CITY PLANNING COMMISSION

- APPLICATION:
- A. Negative Declaration
 - B. Special Permit to develop a 23,000± square foot research/development facility
 - C. Variance to reduce the required 50 foot building setback to 36± feet

PROPOSAL: The applicant is requesting the necessary entitlements to construct a 23,000± square foot building for research and development uses in the Gateway Center PUD

Job No. 8211P
 Scale 1/2" = 1'-0"
 Ref. North 
 Sheet Title
ILLUSTRATIVE SITE PLAN / ROOT PLAN

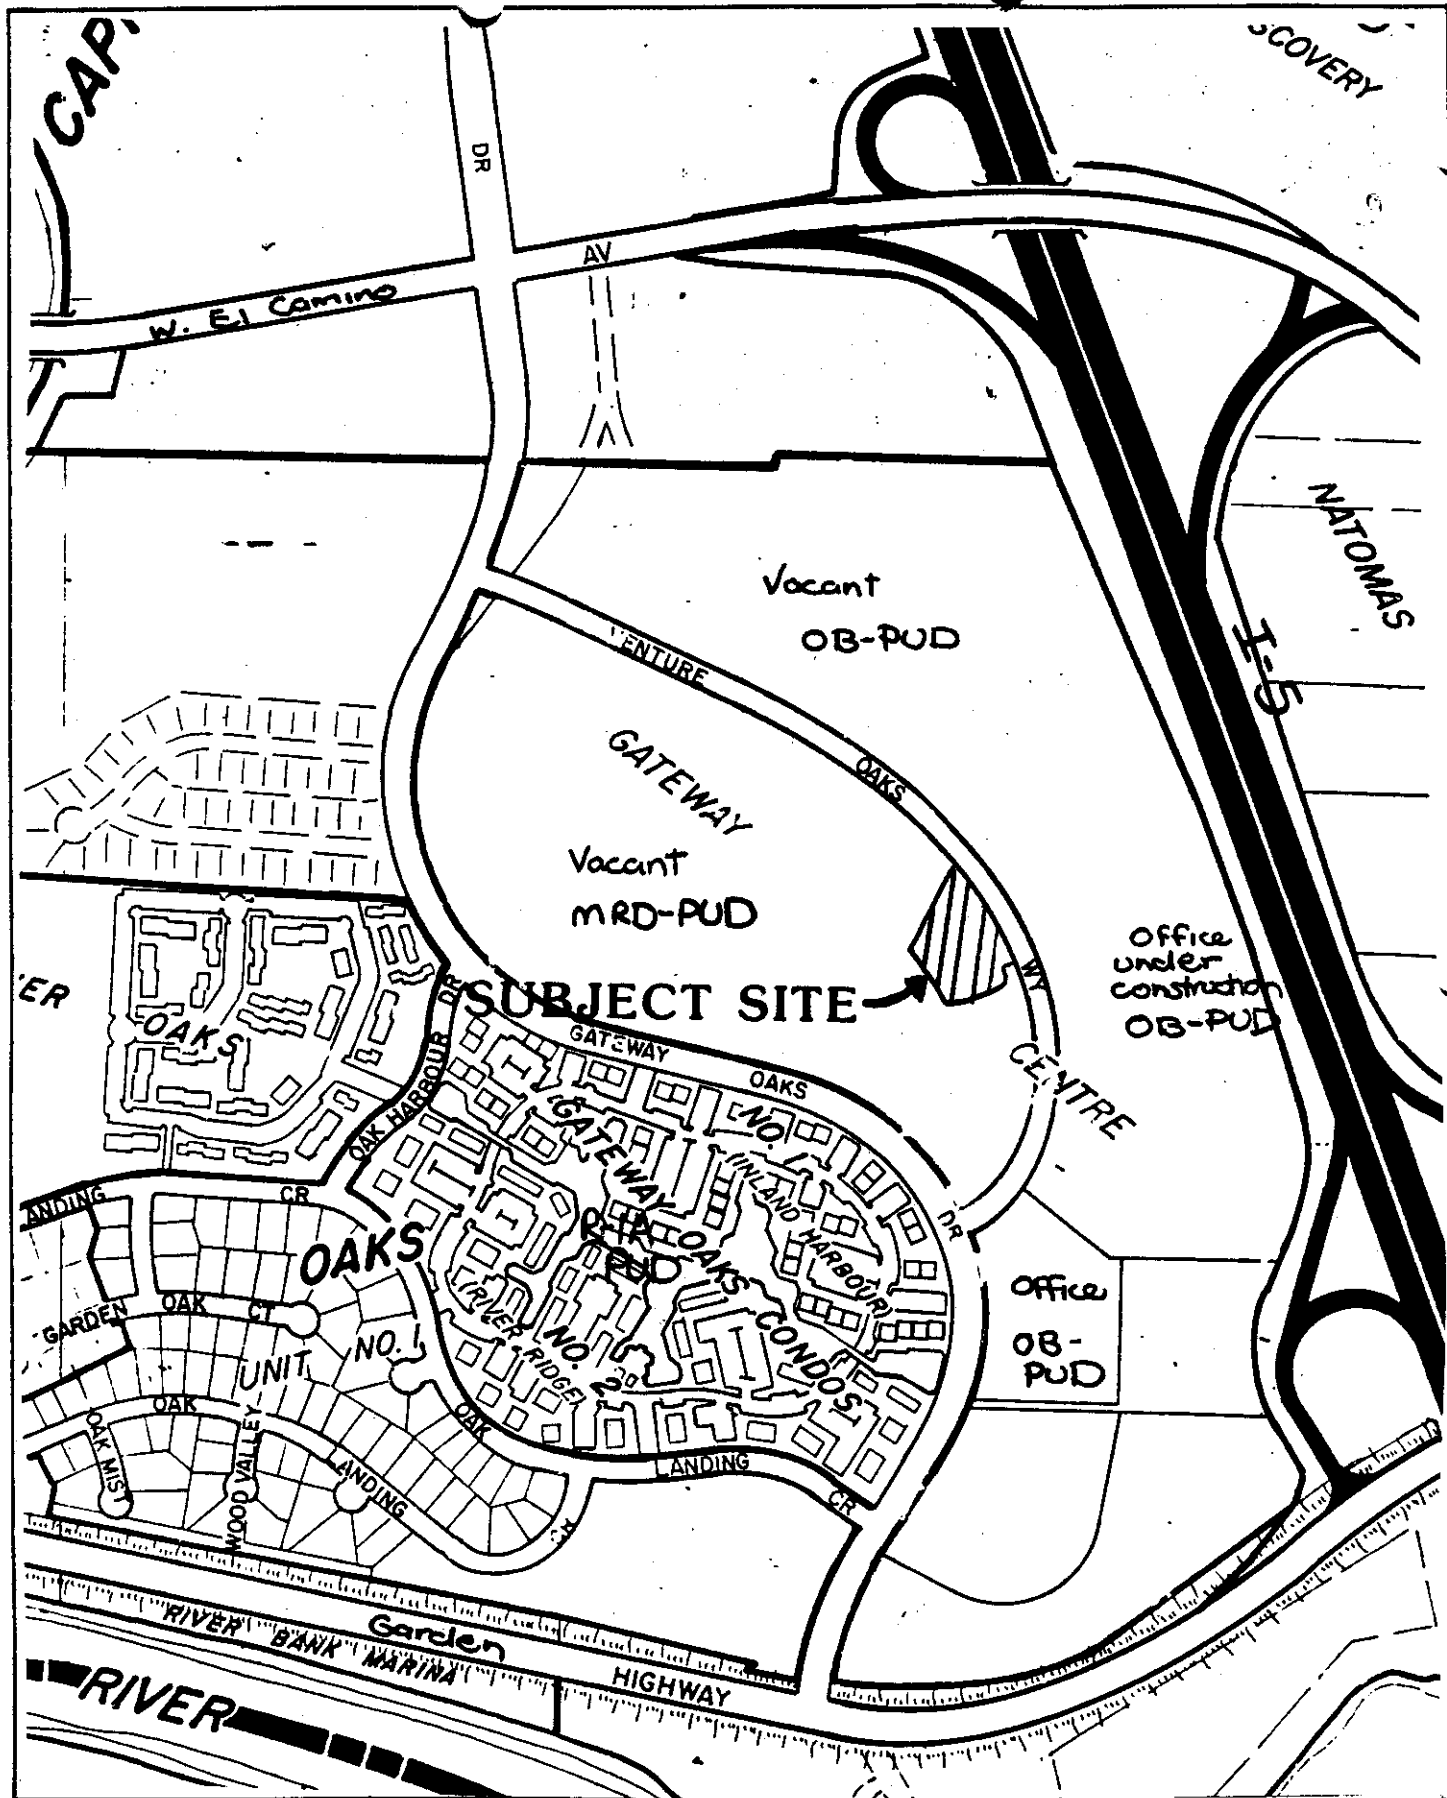
The applicant has designed the site so that all of the on-site parking is to the rear of the building with a 36+ to 43+ foot wide bermed landscaped setback in front of the proposed building along Venture Oaks Way. The City's MRD Ordinance requires a minimum 35 foot setback for buildings adjacent to public streets with right-of-ways of less than 100 feet; such as Venture Oaks Way; however, the PUD Guidelines indicate that the landscape setback on Venture Oaks Way is 25 feet and the building setback is 50 feet. The applicant is requesting a variance to the PUD Guidelines to reduce the building setback to 36 feet, similar to the MRD Ordinance requirement. Staff finds that the applicant's proposal allows for better parking and landscape design, add variety to the streetscape and should not be detrimental to adjacent properties as the proposed building is only one story in height. Staff has no objection to the variance request.

The site plan indicates a serpentine wall in a portion of the front landscape setback on which the company's name shall be indicated. Staff finds this proposed design element acceptable with the conditions that the wall be integrated into the berming subject to staff review and that the proposed sign meet all requirements of the PUD Guidelines.

The site plan also indicates bicycle parking, secured parking for company vehicles and a trash enclosure facility. These areas shall be enclosed and screened in accordance with the Gateway Center PUD Guidelines. Staff also recommends that the secured vehicle area be screened by a six foot high solid masonry wall compatible in design and materials to the main structure.

1. Revised landscape, shading and irrigation plans shall be submitted for staff review and approval prior to issuance of building permits. Undulating berms in the front landscaped setback area shall be four feet. The landscape plans shall follow the approved PUD plant list.

2. The location and design of the proposed serpentine wall and any signage proposed for the wall shall be subject to Planning Director review and approval prior to issuance of building permits.

3. Outdoor secured vehicle storage area shall be completely enclosed with a six foot high solid masonry wall compatible in design and materials to the main structure. The plans for the storage area shall be subject to Planning Director review and approval prior to issuance of building permits.

SCHEMATIC EXTERIOR ELEVATIONS

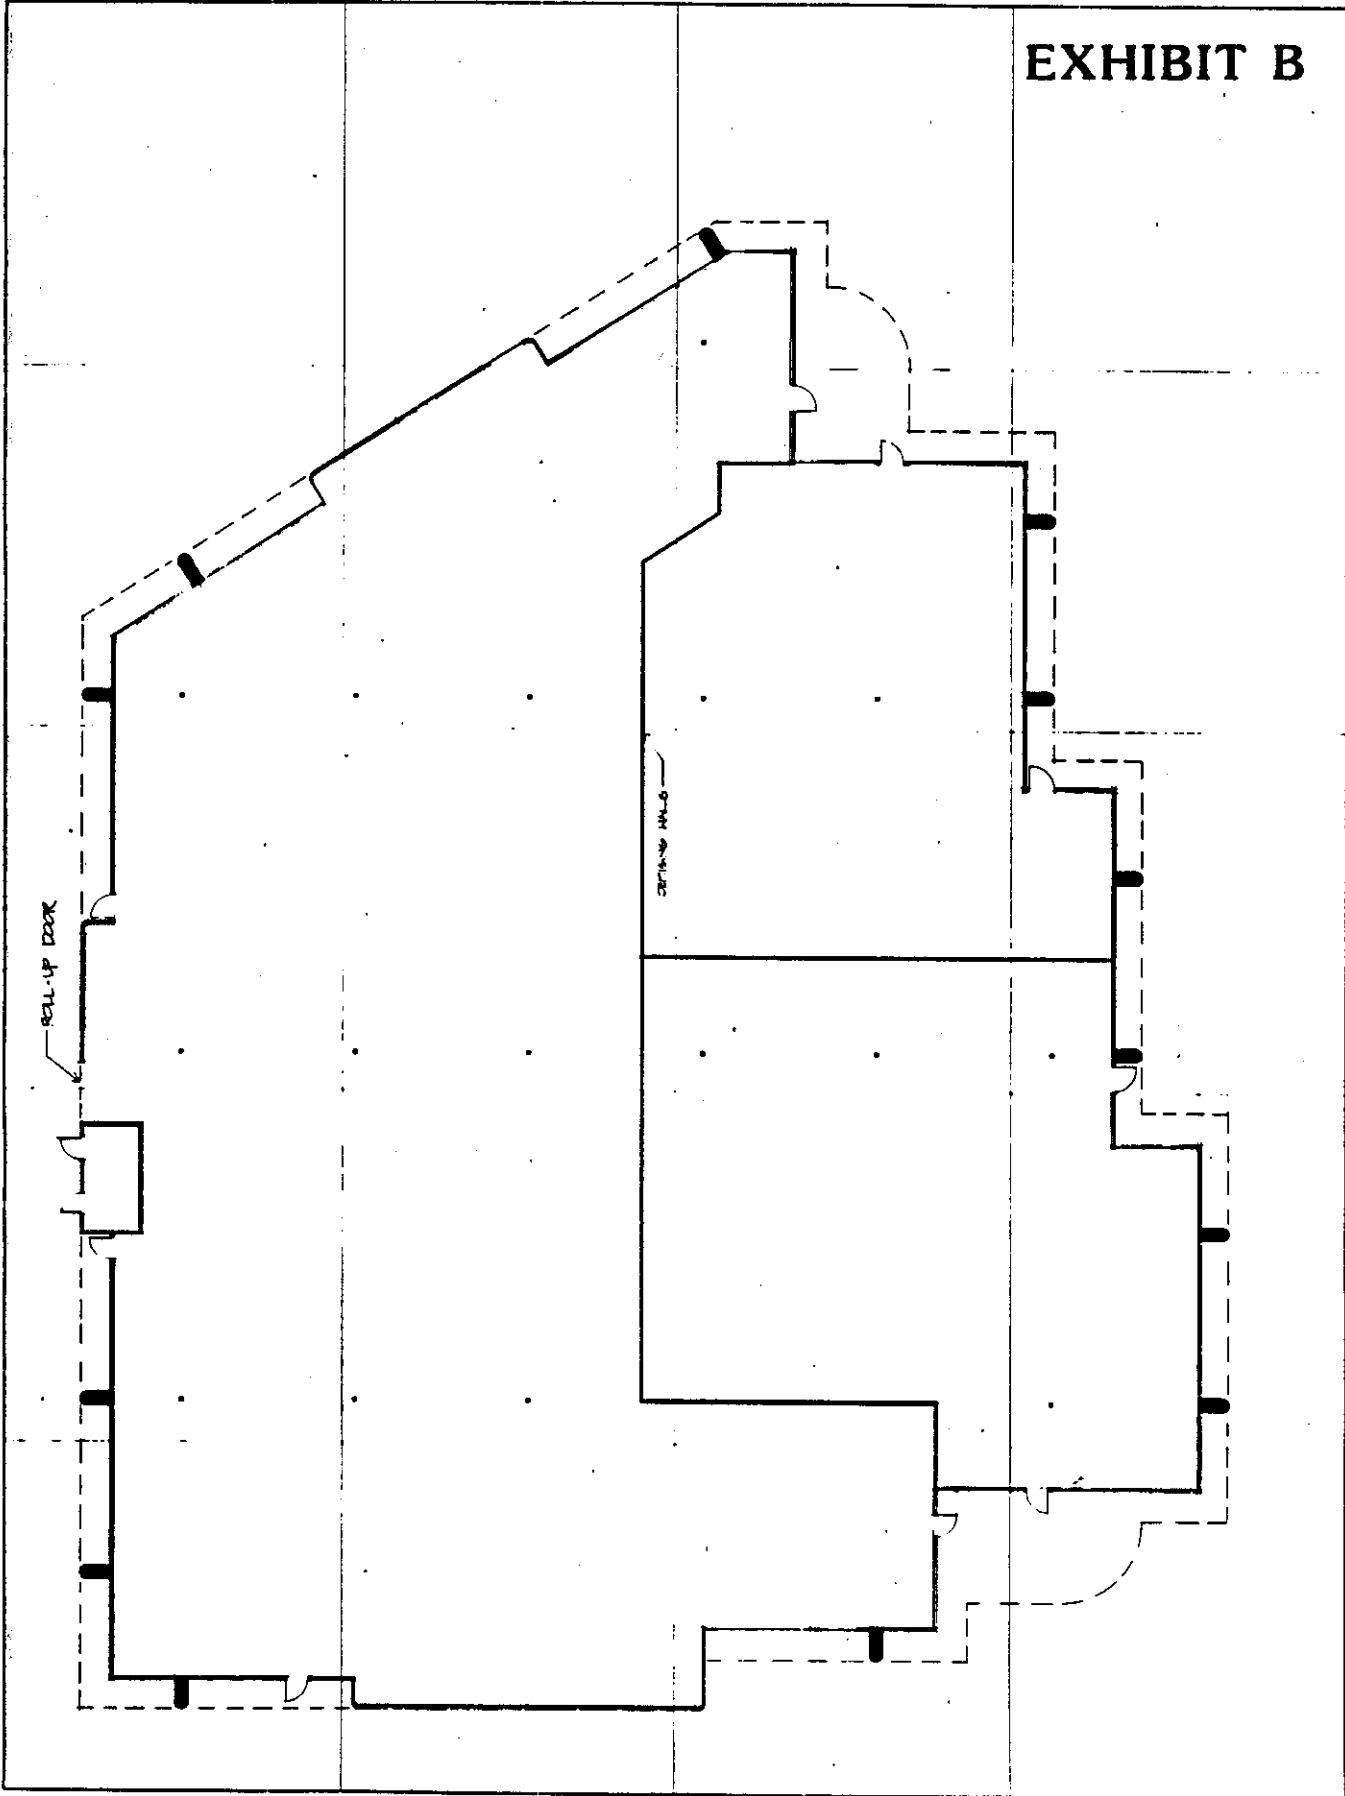
The applicant proposes to construct a one story structure with a stepped back building frontage. Several of the structure's corners are rounded instead of square, adding variety to the building exterior. Proposed materials are brick veneer and glass. Staff finds that the proposed building will be compatible with future buildings in the MRD area.
